ECN/PCN No.: M1642

Product Description: Assembly Power Inductor	Abrakon Part Number / Part Series: AVR-1F140805S	☐ Documentation only ☒ Series ☒ ECN ☐ Part Number(s) ☐ EOL
Affected Revision: Initial revision	New Revision: A	Application: ☐ Safety ☒ Non-Safety

Mechanical Specifications

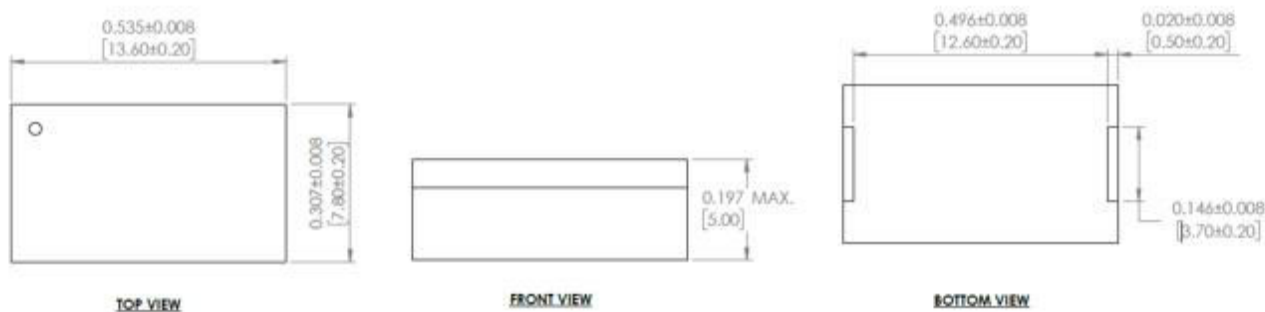
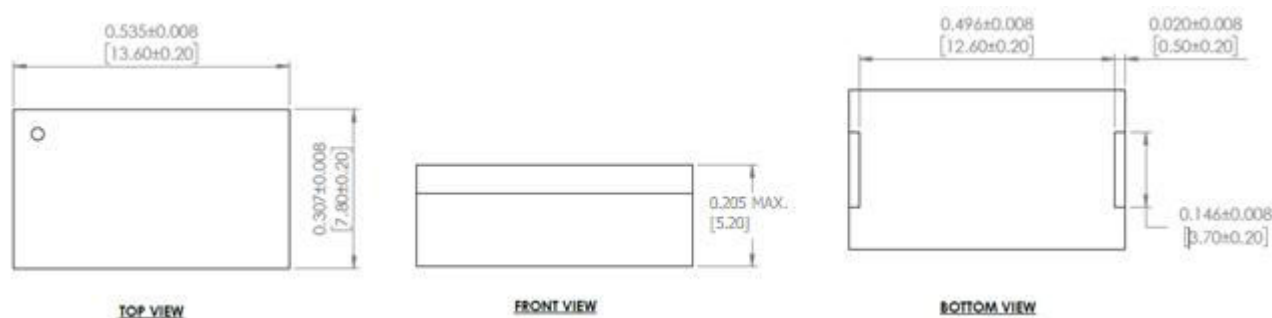
Cause/Reason for Change: Production line recommends increasing package maximum height to 5.2mm. Pieces per reel has increased.		
Change Plan		
Effective Date: 7/8/2025	Additional Remarks:	
Change Declaration: There are no changes to electrical performance of the product. However, the height maximum of the package has increased from 5.0mm to 5.2mm. Package length and width has NOT changed.		
Issued Date: 7/8/2025	Issued By: Gerald Capwell	Issued Department: Engineering
Approval: Syed Raza Engineering VP	Approval: Reuben Quintanilla Quality Director	Approval: Ying Huang Purchasing Director
For Abracon EOL only		
Last Time Buy (if applicable):		Alternate Part Number / Part Series:
Additional Approval:	Additional Approval:	Additional Approval:
Customer Approval (If Applicable)		
Qualification Status: ☒ Approved ☐ Not accepted <i>Note: It is considered approved if there is no feedback from the customer 1 month after ECN/PCN is released.</i>

Tape & Reel: 800 pcs/reel
